LaSalle County Station, Units 1 and 2  
Renewed Facility Operating License Nos. NPF-11 and NPF-18  
NRC Docket Nos. 50-373 and 50-374

Subject: License Amendment Request for Temporary Extensions to Technical  
Specifications Supporting Maintenance on Portions of the Core Standby Cooling  
System

**Figure 1: Unit 2, Division 1 Simplified Sketch**

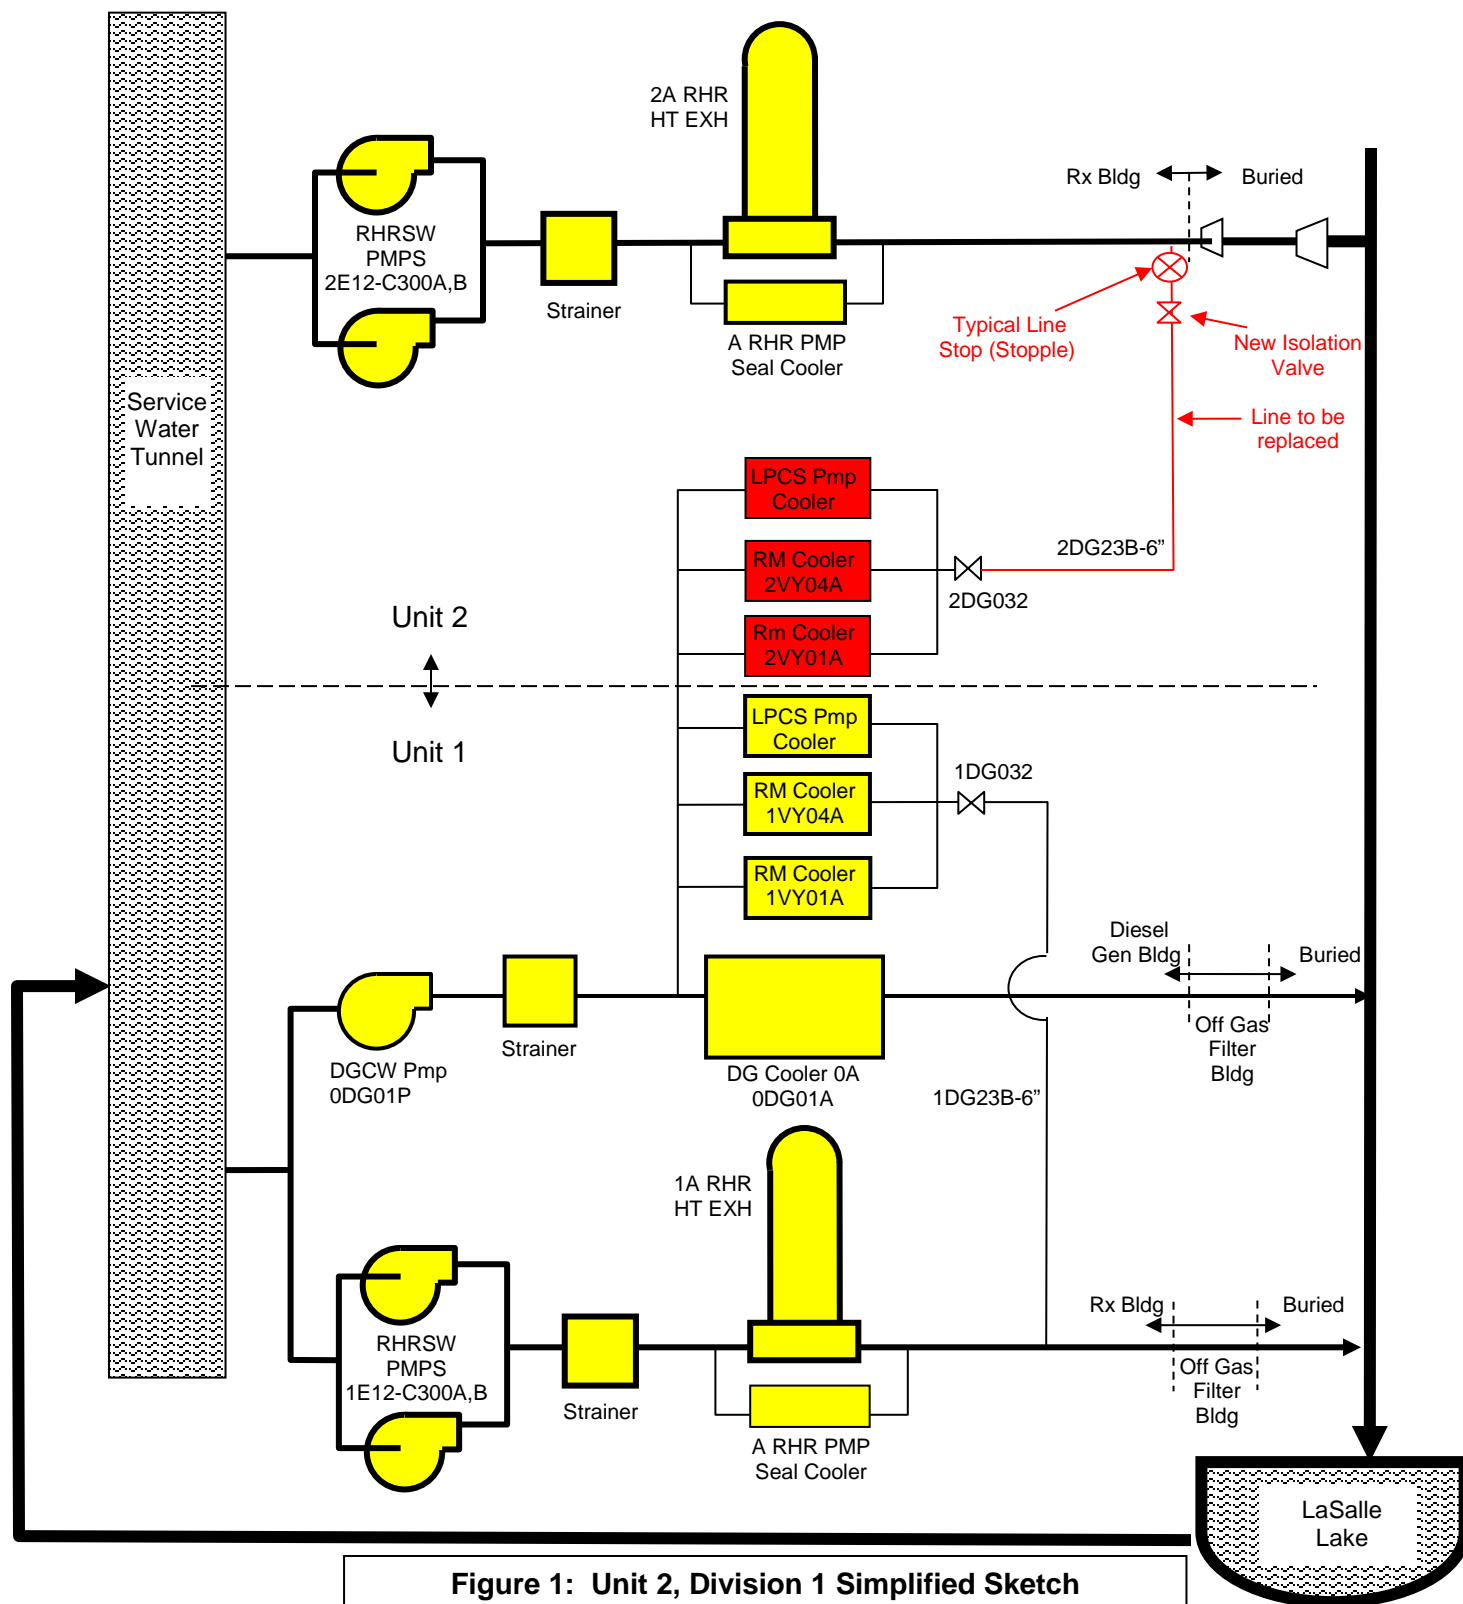
The CSCS is classified as Code Class 3 and is subject to American Society of Mechanical Engineers (ASME) Boiler & Pressure Vessel (B&PV) Code Section III, Class 3 requirements. However, the line stops (stopples) that will be utilized to provide isolation until the new isolation valves are installed are non-Code, see Attachment 2 Figures 5 and 6. During the time the non-Code line stops are used to provide isolation, the affected DGCW subsystem along with the connected RHRSW subsystem will be declared inoperable, see Attachment 2 Figures 1 through 4. The operating unit's subsystems will also be declared inoperable due to common discharge lines within each division. Although inoperable, the use of non-Code line stops is intended to maintain availability of the affected CSCS subsystem, including the Emergency Core Cooling System (ECCS) and DG systems supported in both units. Attachment 2 Figures 1 through 4 are simplified sketches identifying which lines and components will be inoperable and available. The portions of the hot tap hardware permanently attached to the piping will meet Code requirements. The portion of the DGCW return piping which will be replaced will be inoperable and unavailable until replacement and testing is completed, the lines to be replaced and the connected Cooler(s) are shown in Attachment 2 Figures 1 through 4.

**Figure 2: Unit 1, Division 1 Simplified Sketch**

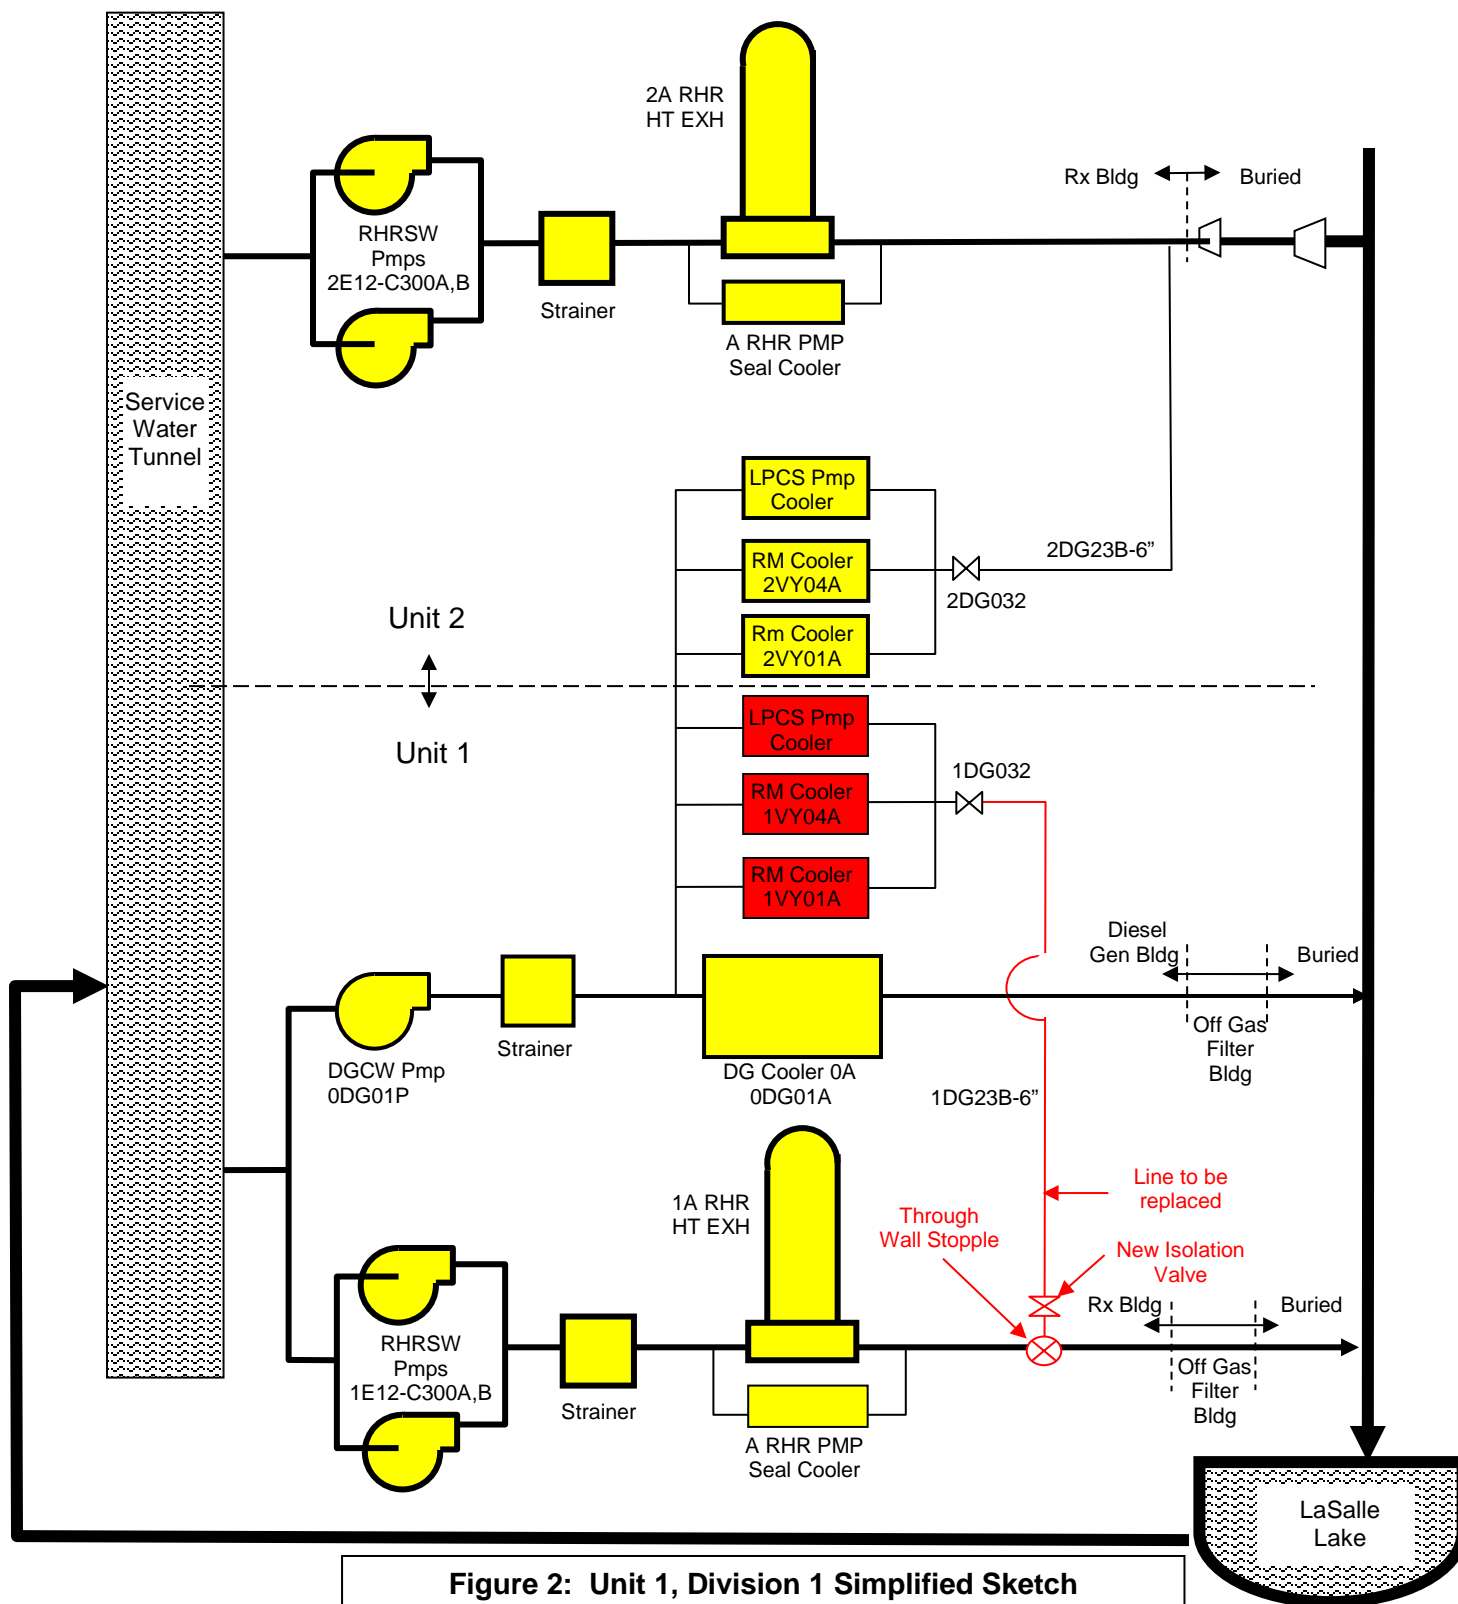
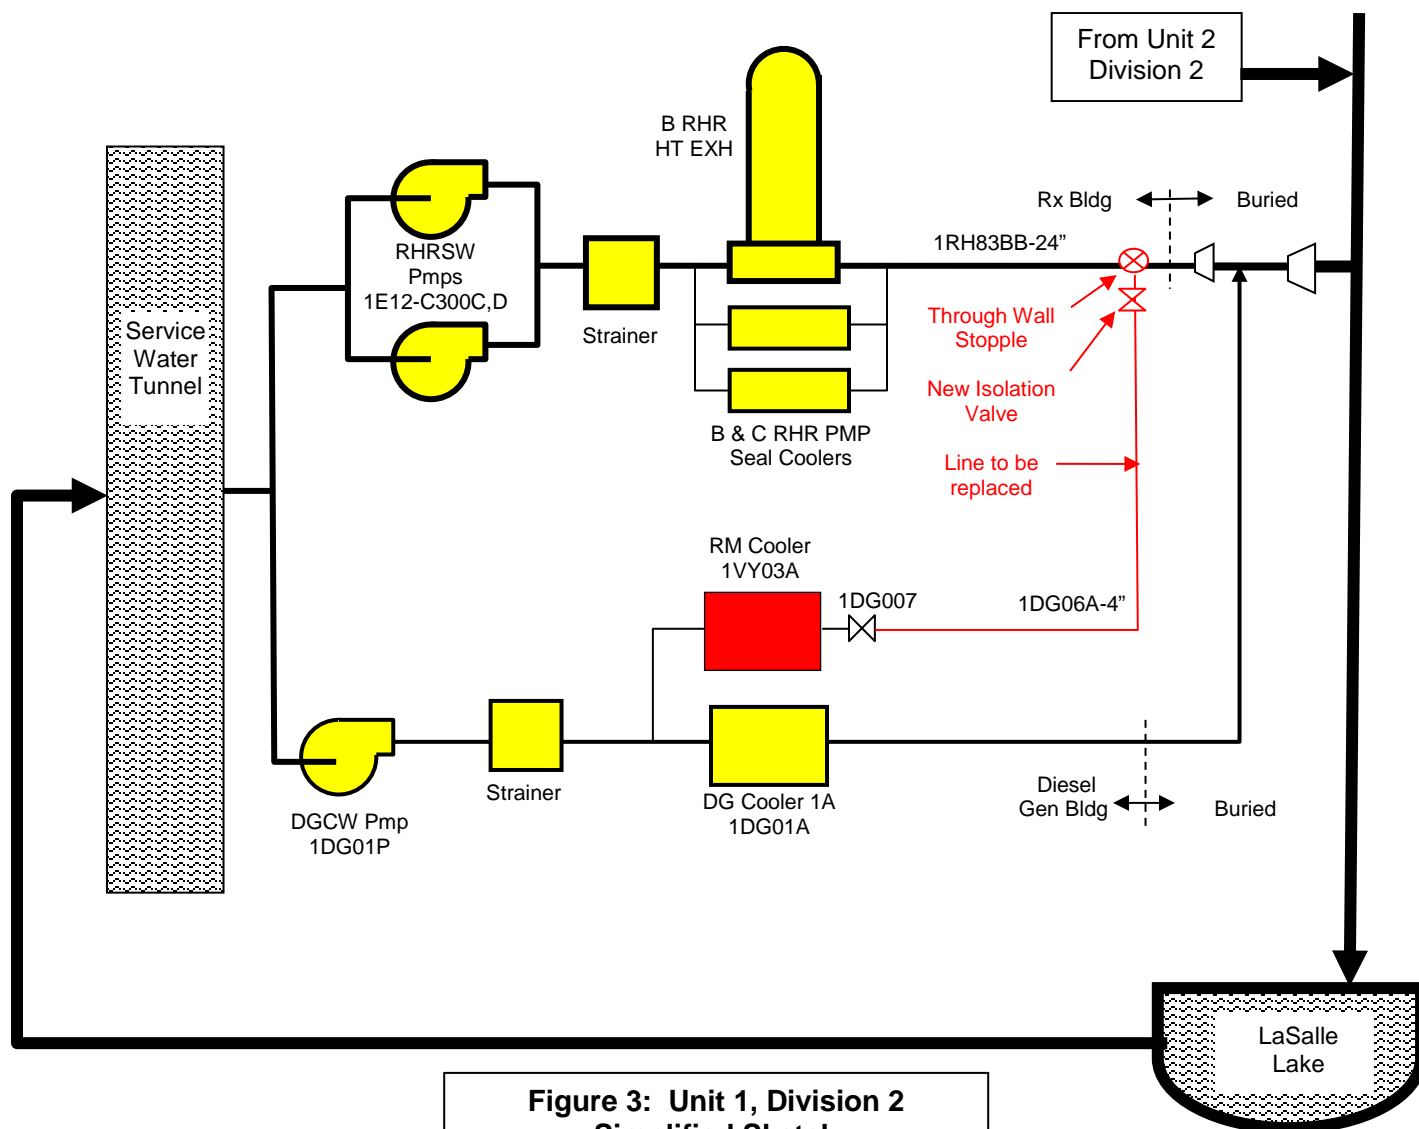
The Division 1 DGCW subsystem of CSCS is common to both Unit 1 & Unit 2

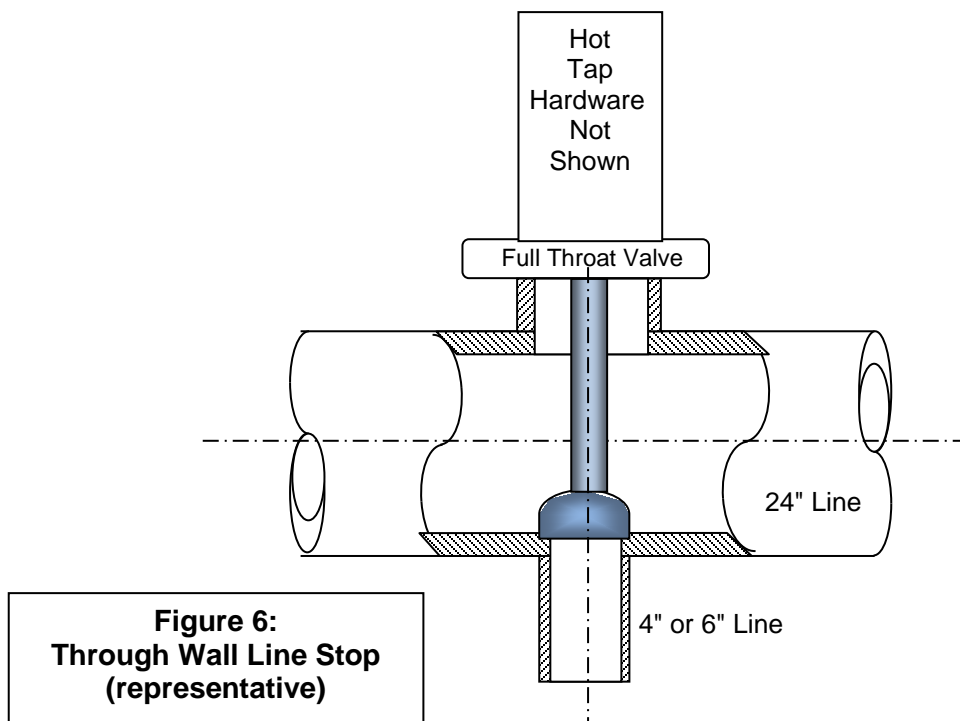
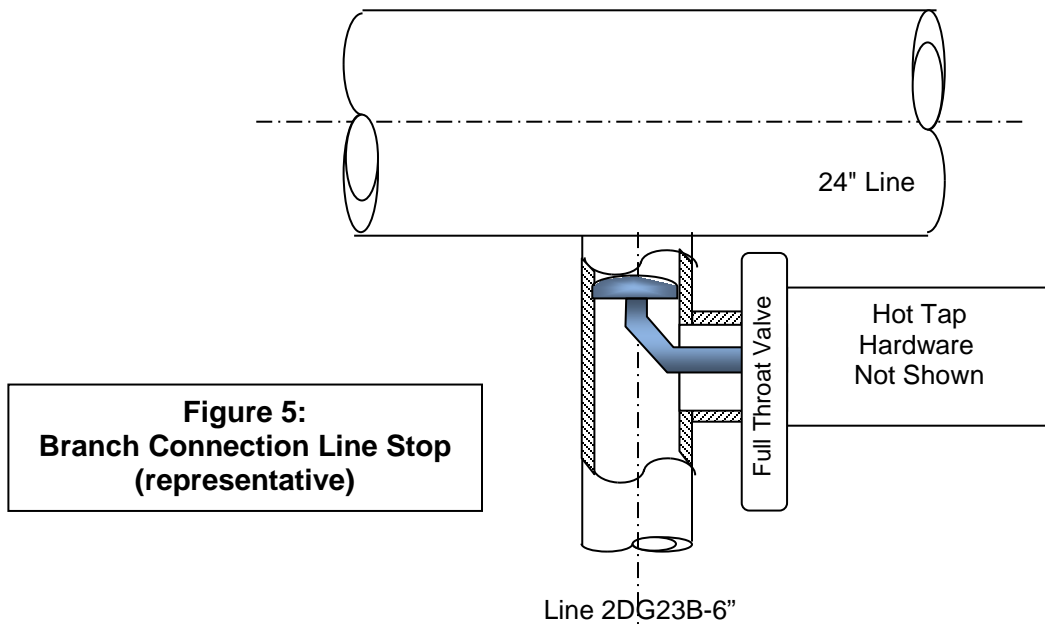
The non-Code line stops being used to isolate the system during the specified refueling outages are being designed to the same or greater pressure rating and seismic requirements as the CSCS piping. Attachment 2 Figure 5 shows a representative image of a branch line stop (stopple), planned for use on Unit 2 Division 1. Attachment 2 Figure 6 shows a representative image of a through wall line stop (stopple), planned for use on Unit 1 Division 1, Unit 1 Division 2, and Unit 2 Division 2. The figures in Attachment 2 represent the anticipated line stop placements, if the preferred through wall line stop becomes impractical, a branch line stop may be used.
